City of **HOBART**

## APPLICATION UNDER HOBART INTERIM PLANNING SCHEME 2015

Type of Report: Committee  
Council: 20 May 2019  
Expiry Date: 18 June 2019  
Application No: PLN-19-167  
Address: 8 FLINT AVENUE , NEW TOWN  
Applicant: Rex Dwyer  
8 FLINT AVENUE  
Proposal: Carport  
Representations: One (1)  
Performance criteria: Inner Residential Zone Development Standards, Historic Heritage Code

Figure 6: Site plan (Skizze Building design, 2019)

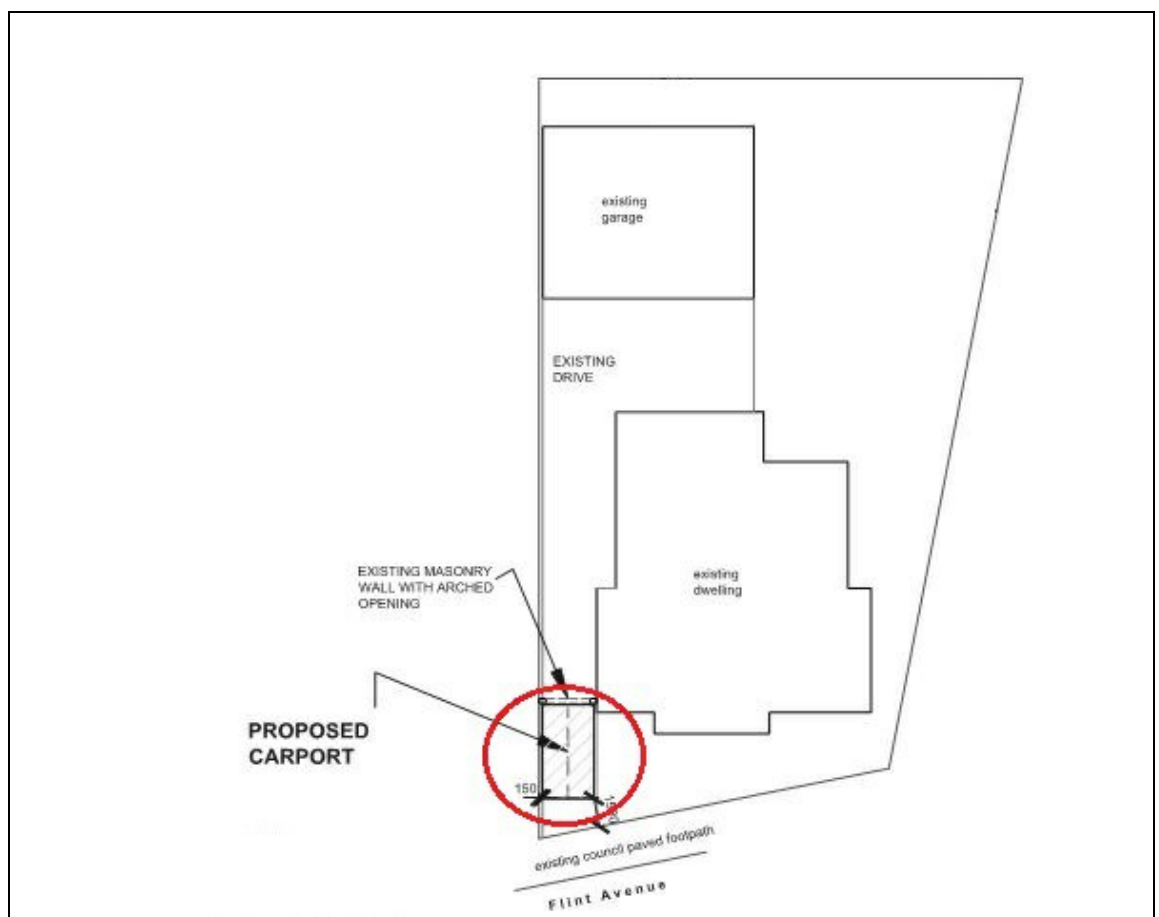
6.7.2 The proposal includes a setback from the front boundary of 1.5m.

- 6.7.5 There are no site constraints that prevent the car port being located behind the building line. The site is flat and an existing driveway extends to the rear of the dwelling.

In this instance the relationship of existing buildings to the road is such that existing development predominantly pursues an historic uniform front setback. The location of the carport in front of the dwelling does not easily integrate this new element into the streetscape and is not compatible with this streetscape.

- 6.8.2 The proposal includes a setback of 1.5m from the front boundary.

- 6.8.5 There are no topographic or site constraints preventing parking behind the dwelling facade. Given the existing uniform setback in the streetscape, the location of the car port 1.5m off the front boundary does not provided a clear separation from the frontage which complements or enhances the streetscape.

6.9.2 The proposal includes a proposed setback of 15cm from the side boundary. There is an existing garage with a side wall of approximately 9m in the rear corner of the site. The addition of a 5m carport on the same boundary totals 14m of development located within 1.5m of the side boundary. The proposal has a 1.5m front setback.

6.9.5 Being located to east of adjoining neighbours, there is a limited potential for a reduction in sunlight to a habitable room of that dwelling. However, because the carport is sufficiently low in profile and without walls, the impact of overshadowing to that dwelling should be short lived on 21st June.

Consequently, as the carport will still enable more than 3 hours of sunlight to the front habitable room of the adjacent dwelling and is therefore considered acceptable in this instance.

- 1 The proposal does not meet the acceptable solution or the performance criterion with respect to clause 11.4.2 A1 and P1 of the *Hobart Interim Planning Scheme 2015* because the setback of the carport does not have regard to streetscape qualities or assist the integration of the carport into the streetscape.

- 2 The proposal does not meet the acceptable solution or the performance criterion with respect to clause 11.4.2 A2 and P2 of the *Hobart Interim Planning Scheme 2015* because the setback of the carport does not provide separation from the frontage that complements or enhances the existing streetscape.

Figure 7: Elevations and Floor plans for carport (Skizze Building design, 2019)

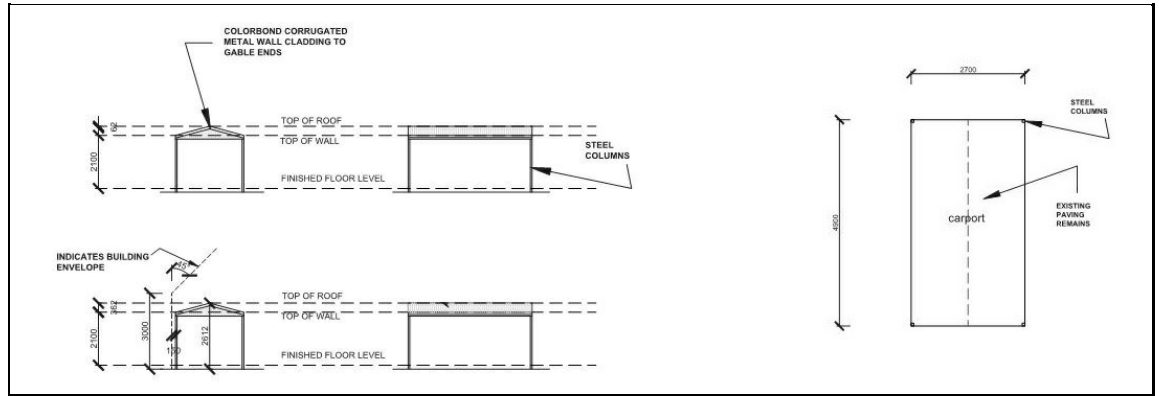
The proposal seeks the erection of an open sided single width carport over the existing driveway to the front garden, forward of the front building line. The carport would be of a steel pole and colourbond construction with enclosed gable ends.

Whilst the proposed car port would be open sided, it would nonetheless be a highly visible structure. Clearly departing from the pattern of development and utilising a design and use of materials, it would also erode the garden setting of the property and its clear sense of setback in line with the wider street. It is considered that the resulting development would stand contrary to the otherwise consistency of streetscape appearance and would diminish not only the sense of integrity of the individual property, but to that of the wider precinct.

Given the above, it is therefore considered that the proposed car port would fail to be sympathetic to the character of the precinct to the detriment of its clearly identified consistency and integrity of style, setback, garden setting and cohesive architectural style. As such, it is

- 3 The proposal does not meet the acceptable solution or the performance criteria with respect to clause 13.8.2 A1 and P1 of the *Hobart Interim Planning Scheme 2015* because the proposed carport, by reason of its location forward of the front building line, would have a detrimental impact upon those features which contribute to the historic cultural significance of the Flint Avenue Heritage Precinct (NT12) as set out in table E.13.2.
